NUREG-0661

# **Safety Evaluation Report**

Mark I Containment

Resolution of Generic Technical Activity A-7

Figure 3.5-4 Cylindrical target drag coefficient following impact.

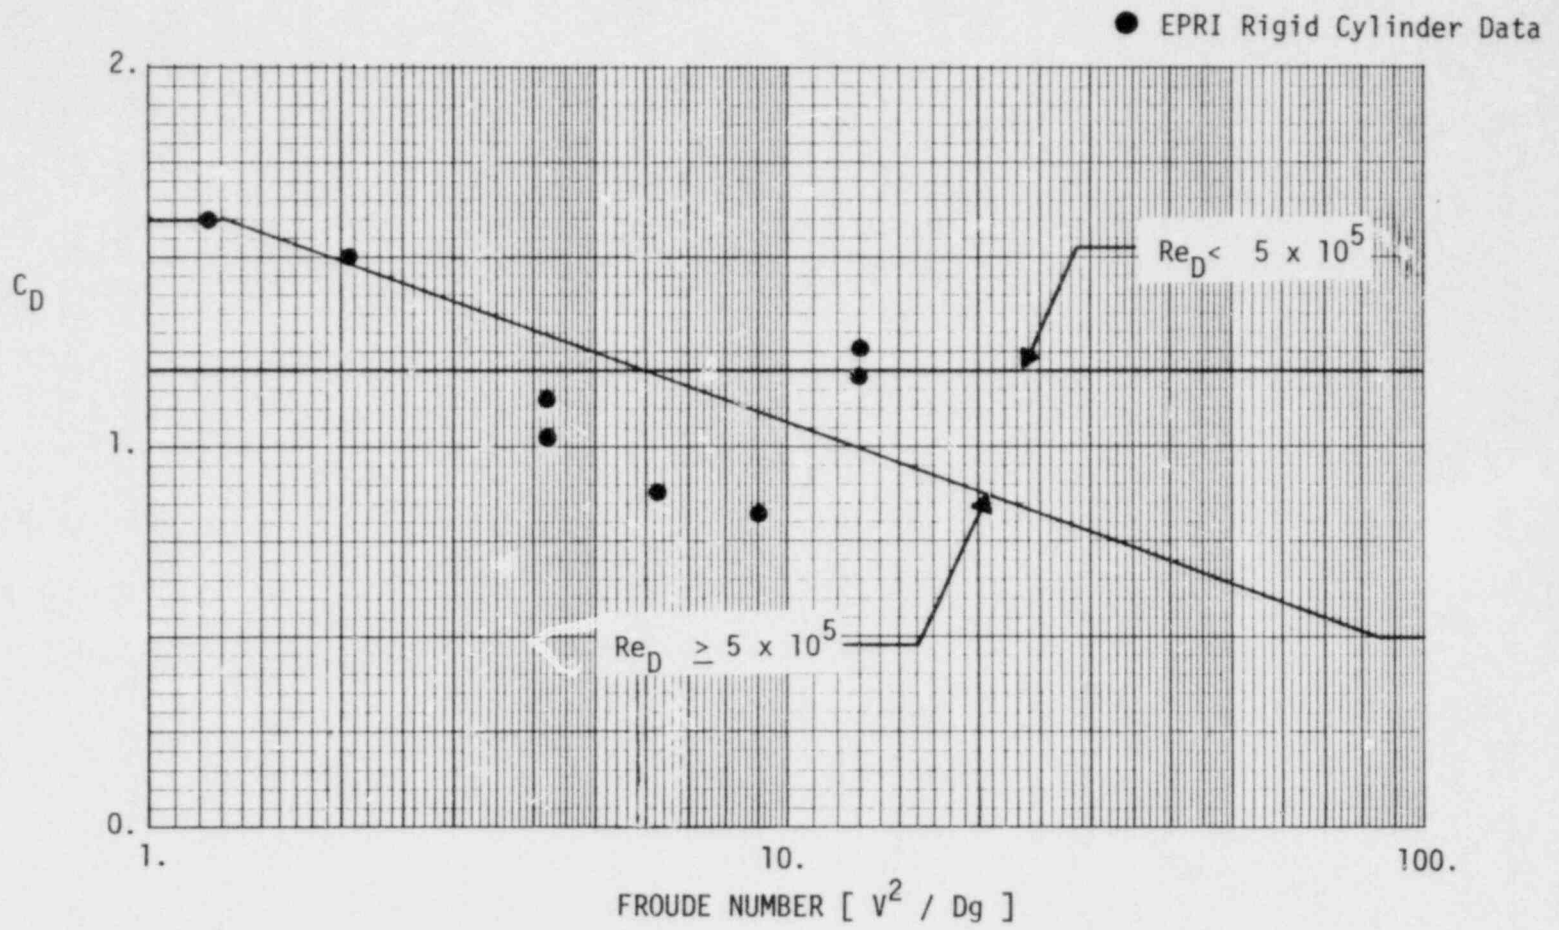
The acceptance criteria for drag following impact contain separate specifications for laminar and for turbulent flow. When the flow is laminar, a standard drag coefficient is used. With a ventilated wake, some reduction in  $C_D$  may be realized; however, since the rigid cylinder impact measurements were not in the laminar

regime, it is not possible to quantify this reduction. Thus, a value of 1.2 will be used when Reynolds number is less than  $5 \times 10^5$ . When the flow is turbulent, a curve drawn through the measurements, as shown in Figure 3.5-4, has been specified for the drag coefficient. At Froude numbers greater than 85, a constant value has been specified, corresponding to the limiting case of a fully cavitating wake.

Figure 3.8-3 Condensation oscillation amplitude - frequency spectrum.

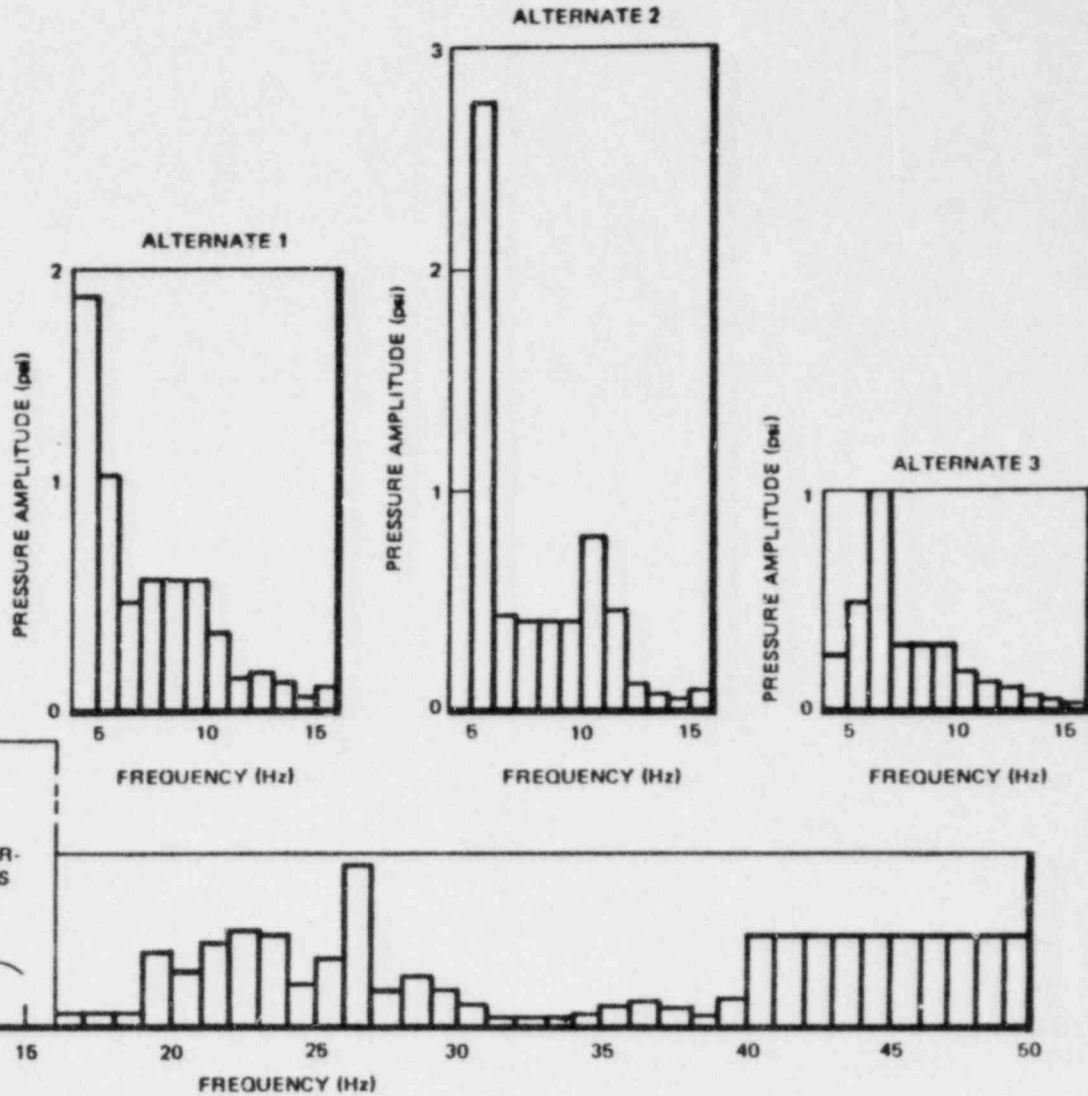
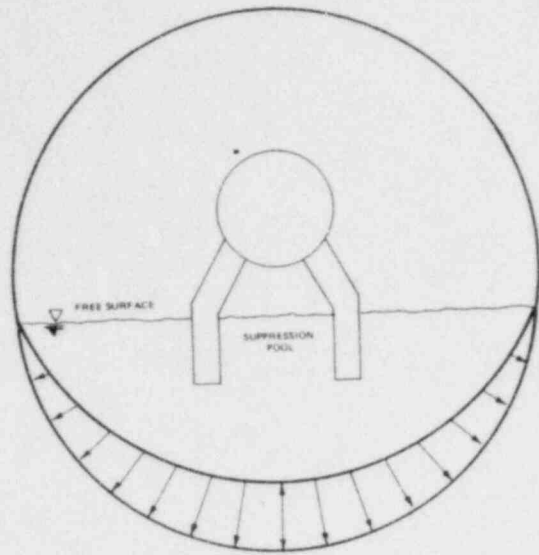
The load specification proposed in the LDR was derived from selected periods of maximum-amplitude test data. Optional pressure amplitude-frequency spectra are included to ensure that the maximum pressure amplitude has been specified

for those frequencies for which the structure might be sensitive. The FSI model used to derive the pressure amplitude-frequency spectra incorporates assumptions that are not necessarily conservative by themselves. However, the overall conservatism of this technique is demonstrated by comparisons of the predicted structural response using the load specification and the measured structural response in the FSTF (Ref. 45).

Figure 3.9-3 Multiple downcomer chugging load probability distribution.

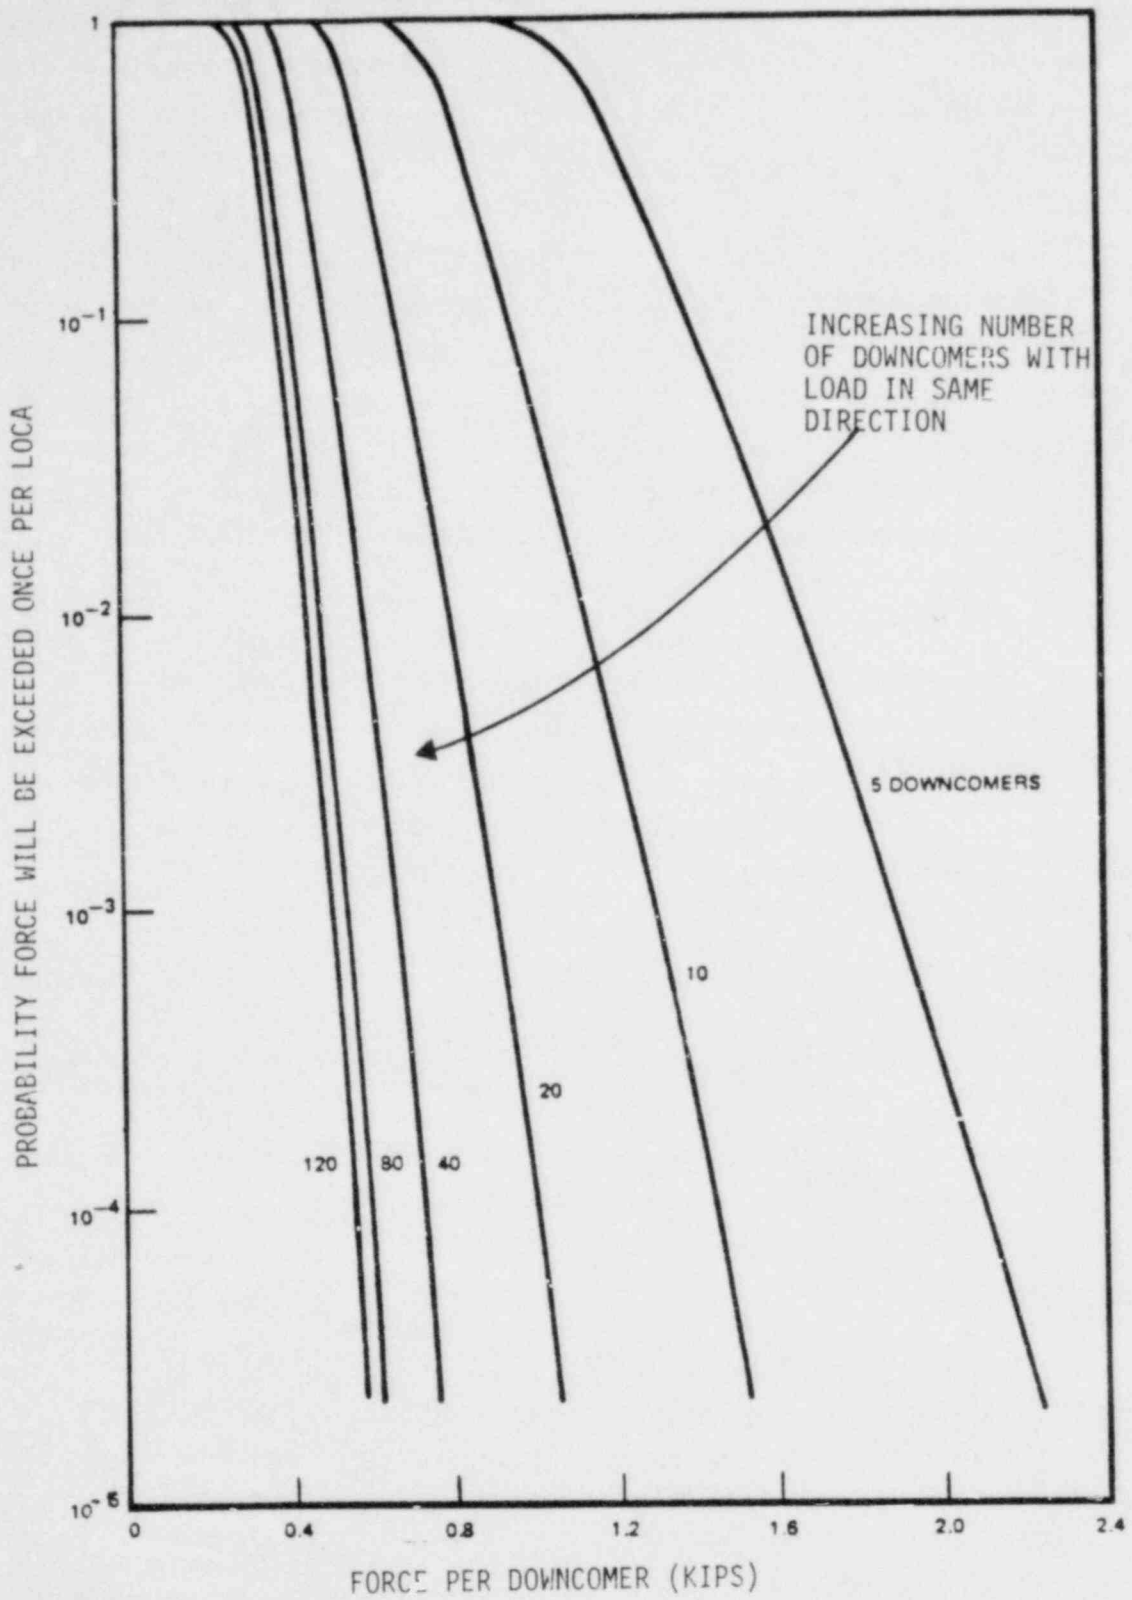
This requirement relates to the potential for a number of downcomers experiencing a lateral load in the same direction at the same time, producing a net loading on the vent system and its supports. The load magnitude probability function shown in Figure 3.9-3 was derived from a statistical analysis of the RSEL/phase direction data from the FSTF. The staff concluded that the combined probability of a LOCA and the probability of a specific downcomer lateral load on any number of downcomers should be less than  $10^{-7}$  per reactor-year, and, in consideration of the small load increase associated with the lower RSEL probability levels, the staff concluded that a probability of exceedance of  $10^{-4}$  per LOCA would be adequately bounding.

Figure 2.10-1 Impact Force Transient for Addition to the Empirical Data for Deflector Types 1 - 3.

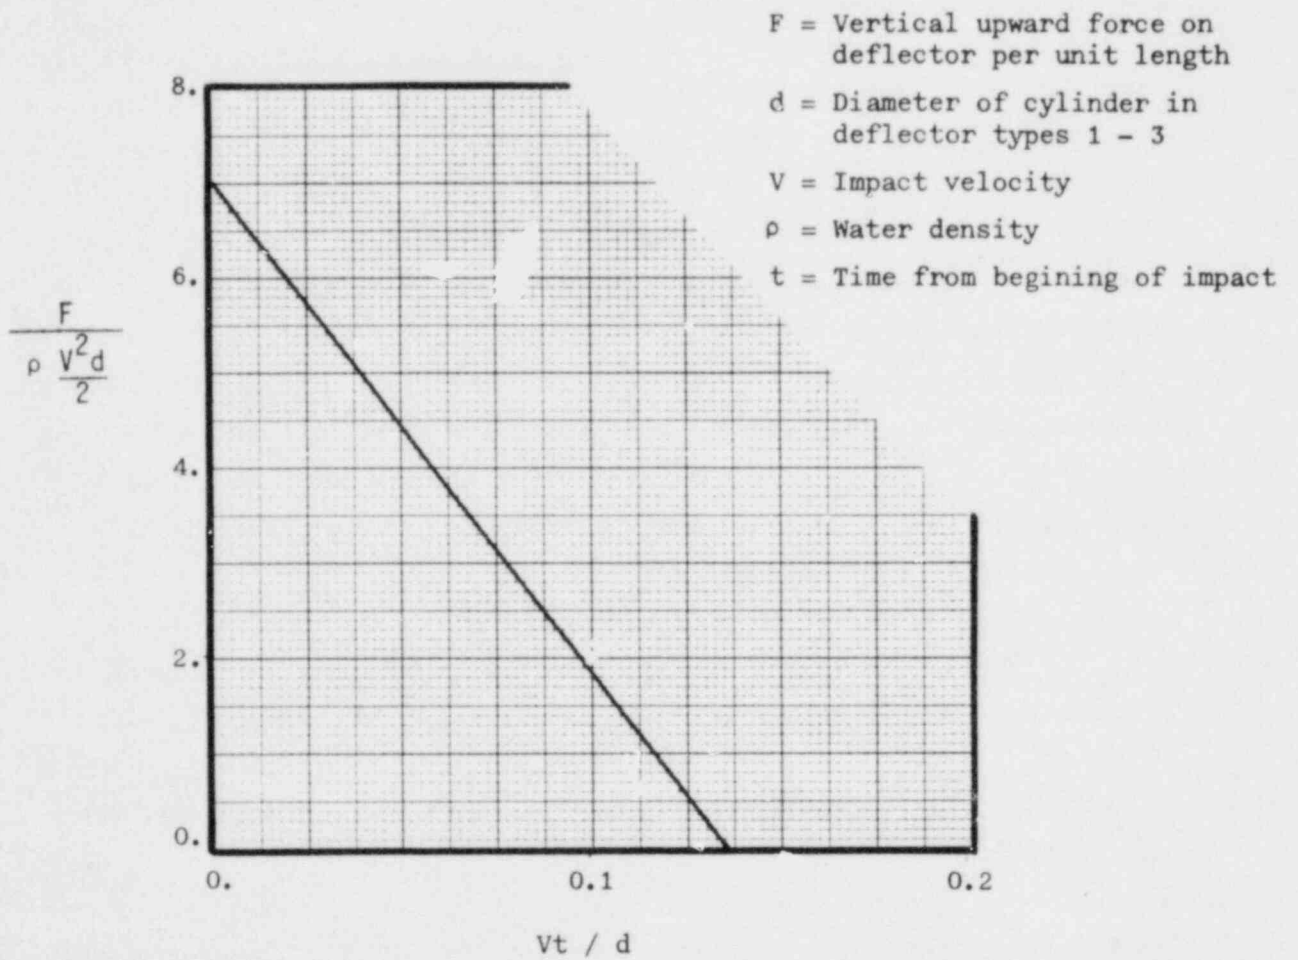
1. If the QSTF deflector load measurement does not have a sufficiently fast response time to resolve the initial impact pressure spike for the deflector types 1-3, inclusive, the loading transient shall be adjusted to include the empirical vertical force history of the spike shown in Figure 2.10-1. This impulse need not be applied for the type 4 deflector.
